SERVICE BULLETIN

2018 MURANO; BRAKE BOOSTER DESIGN CHANGE

APPLIED VEHICLES: 2018 Murano (Z52) **APPLIED DATE:** February 14, 2018

NTB18-054

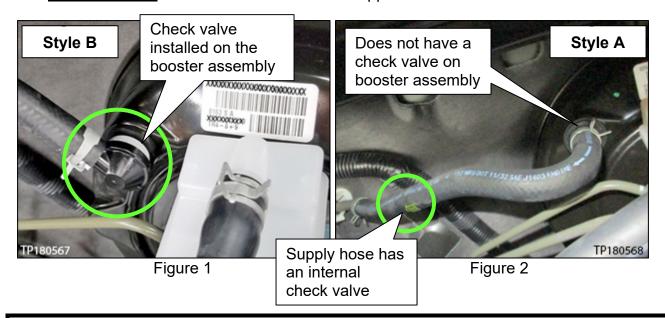
A change has been made to the brake booster assembly (booster) and brake booster supply hose (supply hose) for the Applied Vehicles built on or after the Applied Date.

- Vehicles built on or after the Applied Date will have the booster's vacuum supply check valve installed onto the booster (style B) instead of being part of the supply hose.
- Vehicles built before the Applied Date will continue to use style A.

IMPORTANT: Style B booster and supply hose <u>are not</u> interchangeable with style A parts, and cannot be used on vehicles built before the Applied Date.

Visually confirm which style of booster is original equipment for the vehicle before ordering replacement parts.

If the vehicle was manufactured in February 2018, visually confirm if style A or style B parts are present before ordering replacement parts.
